4.3 SURFACE WATER AND FLOODING

This section responds to submissions which questioned the characterisation of the existing condition of the Mooki River.

Figure 24
Final Landform Catchment Boundaries

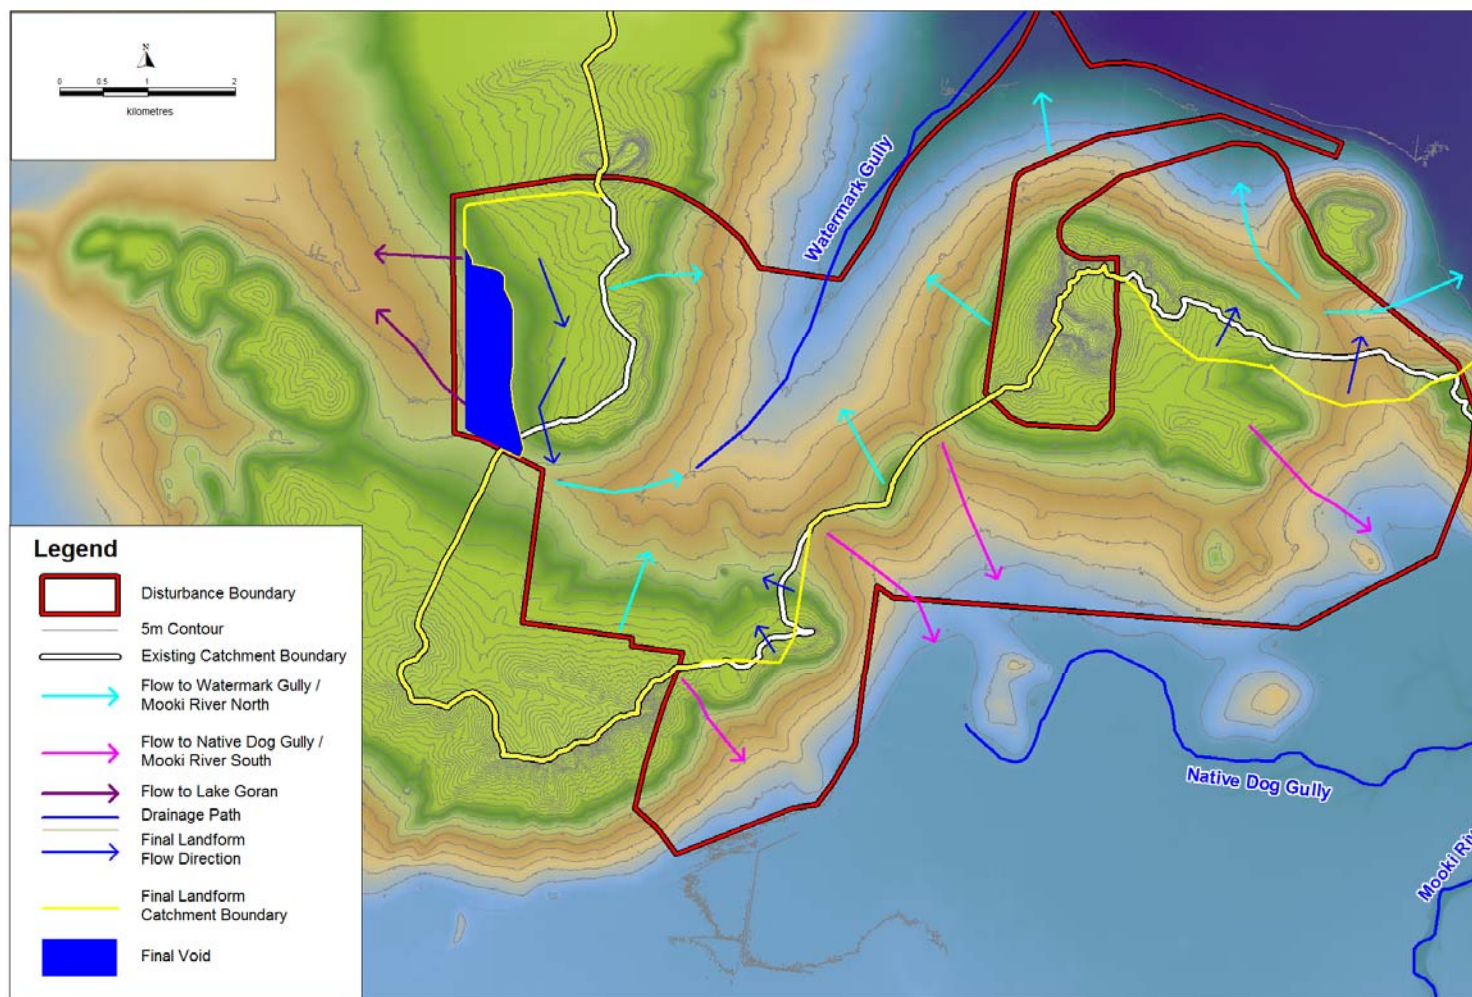
A number of submissions raise a concern with the potential for Watermark Gully to be affected by a reduction in catchment of 25%, as stated in the Executive Summary and Section 11 of the Surface Water Impact Assessment. This percentage refers to the Year 30 mine plan and does not account for the areas of established rehabilitation where runoff will be released offsite (which reduces the catchment loss) and as a result is not a true reflection of the loss of catchment and downstream flow.

This also reduces the increase in Watermark Gully catchment post mining (from 13% to 9%). Further detail is provided on the revised loss of catchment assessment in the following sections.

The final landform catchment boundaries are shown in **Figure 24**. The net change in catchment area draining from the site is summarised in **Table 10**. The changed topography as a result of the Project final landform will have the following impacts on catchment areas:

Figure 31
Watermark Gully TUFLOW Model Configuration

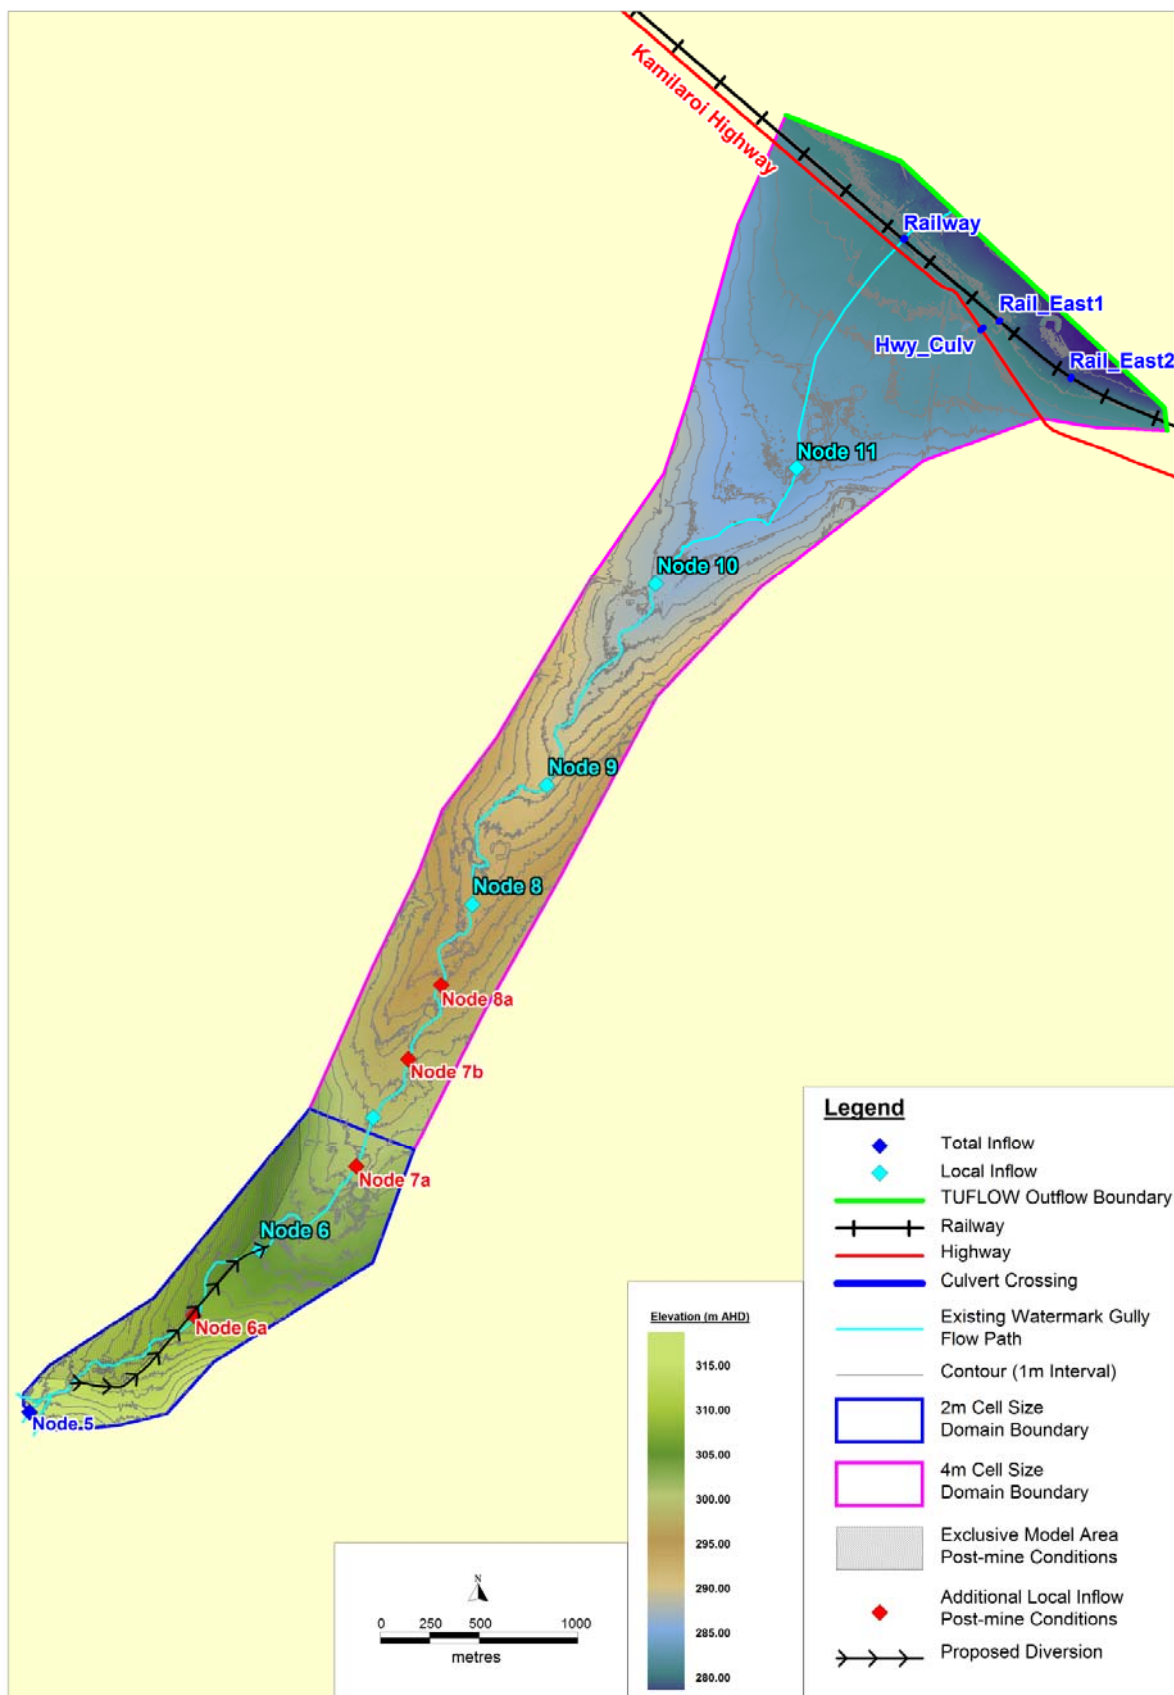
A number of submissions related to the impacts of the Project on flooding at the Kamilaroi Highway crossing of Watermark Gully. Flood impacts on Watermark Gully have been investigated in further detail as part of this RTS using a two-dimensional hydraulic model as described in the following sections.

Figure 31 shows the spatial extent of the Watermark Gully TUFLOW model for existing (pre-mine) conditions. The model extends about 7.5 km upstream and 0.3 km downstream of the Kamilaroi Highway. The modelled study area covers approximately 6.4 km². A fine 2m grid size and a one second time step were adopted for the upper catchment to assess the proposed Watermark Gully diversion. A 4 m grid size and 2 second time step were adopted for the lower catchment to assess the flood impact on the Kamilaroi Highway.

Figure 31 also shows the locations of the 2D inflow and outflow boundaries adopted in the TUFLOW model. The existing conditions TUFLOW model includes seven inflow boundaries along Watermark Gully. The names of the inflow boundaries correspond to the names of the sub-catchments in the RAFTS model described in the Surface Water Impact Assessment.
